CHANNEL DRIVE & CHANNEL VISTA PUMP STATION REHABILITATION Contract No. BE21-148

ADDENDUM NO.: TWO

DATE ADDENDUM ISSUED: December 8, 2020

3 ELECTRICAL ENCLOSURE - SOUTH WALL INTERIOR ELEVATION PLAN
E4

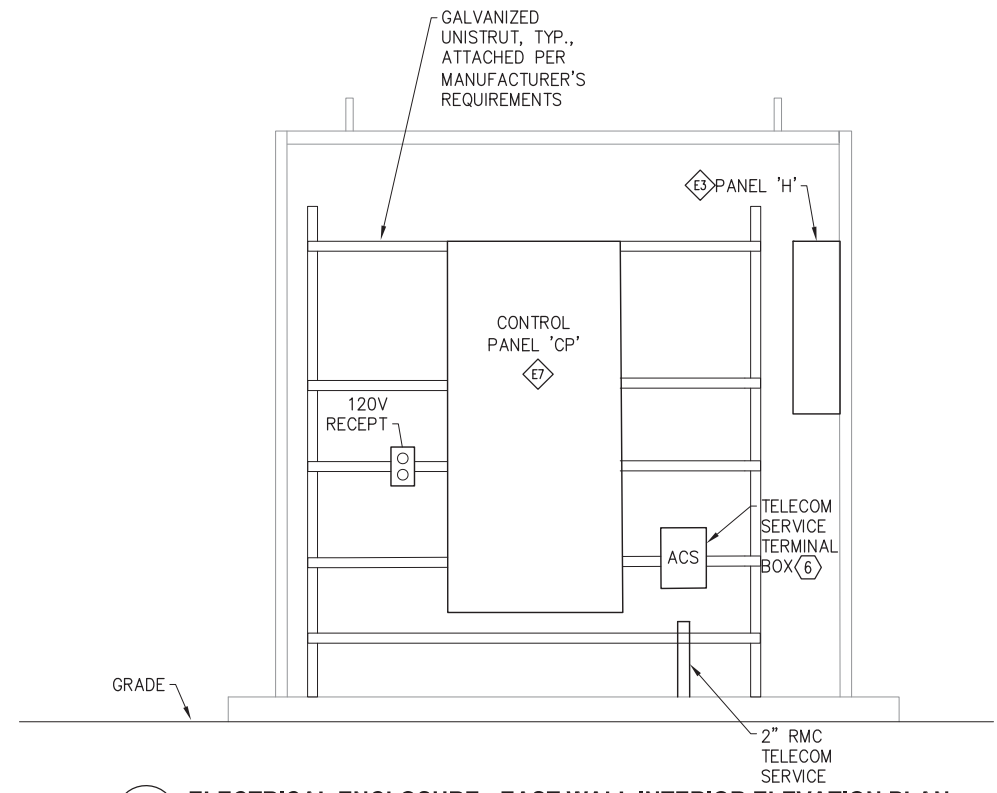
Question: "Sheet E4, detail 2, shows equipment tag E6 as a main generator disconnect. Same sheet, detail 3, shows a similar disconnect on the interior of the new enclosure. Please clarify intent and purpose of interior disconnect, or confirm that this is mislabeled, and should be E7 (Control Panel)."

Response: Sheet E4, Detail 3 has been revised so the control panel is correctly labeled as Item E7 on the equipment schedule; see drawing Item No. 1 in this Addendum.

1 CHANNEL DRIVE ELECTRICAL - POWER ONE-LINE
E5

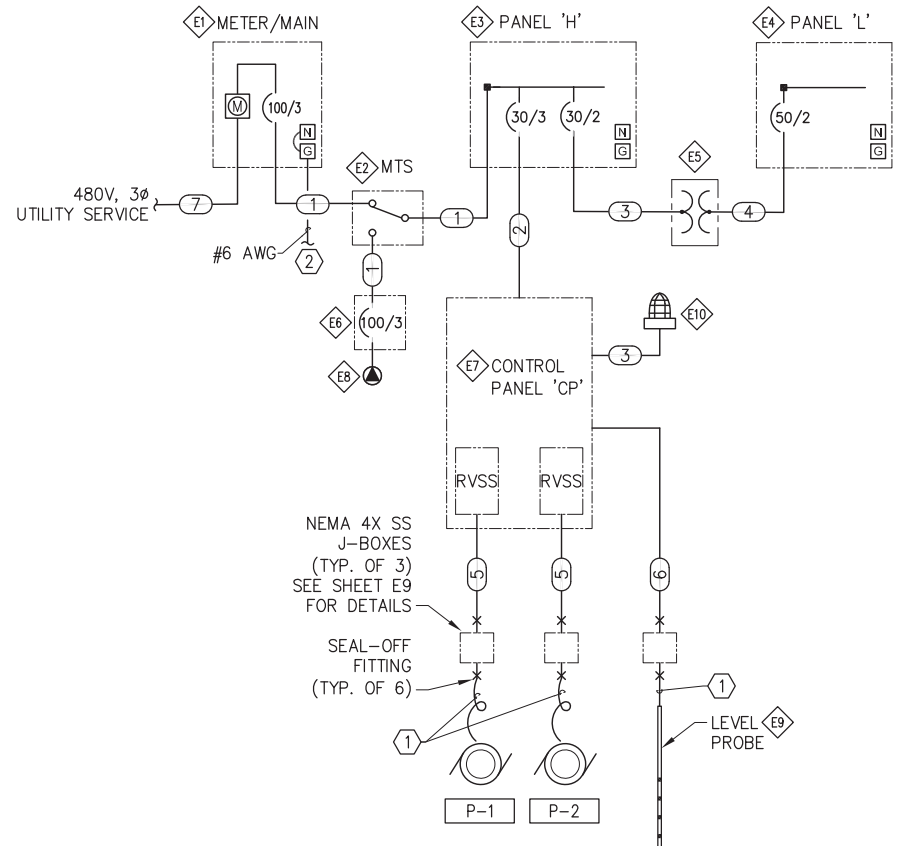
Question: "Please confirm that item 'E2' on the equipment schedule (sheet E5) does not include the '3-pole receptacle' as it is outlined below as equipment item 'E8.'"

Response: Sheet E5 has been revised to delete "with 3-wire, 3- pole receptacle" from Electrical Equipment Item E2 description on the equipment schedule; see drawing Item No. 2 in this Addendum.
